ADDENDUM NO. 2

DATE: November 9, 2022
FROM: City of Grand Junction Purchasing Division
TO: All Offerors
RE: IFB-5145-22-DD 2022 Sewer Replacement UnawEEP Avenue Project

EXHIBIT B

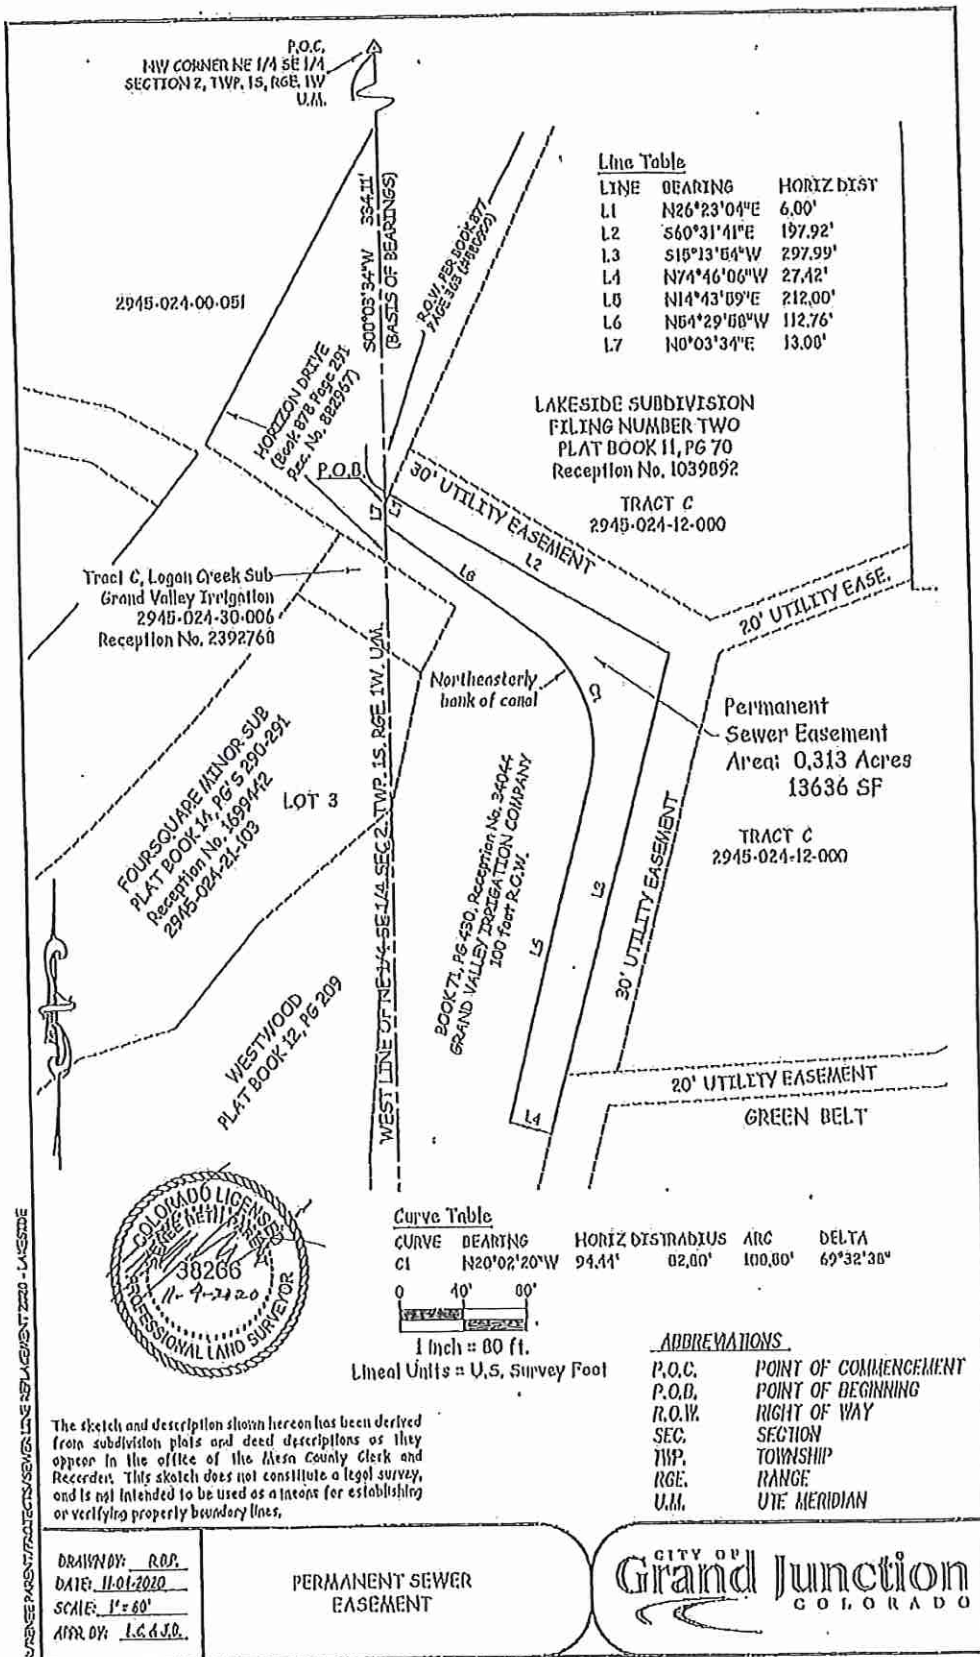
15. **Question:** The proposed alignment of the Lakeside sewer is not located entirely within the 30-foot easement shown on the plan sheets. Please clarify if Contractor will be required to stay within the existing easement.

Answer: The City has secured additional easements from the Grand Valley Irrigation Company that are reflected by the dashed lines on Sheet 55 of the Construction Drawings and shown on the Exhibit B included with this addendum. <http://trimview.gjcity.org/?=SOLDOC/25022>
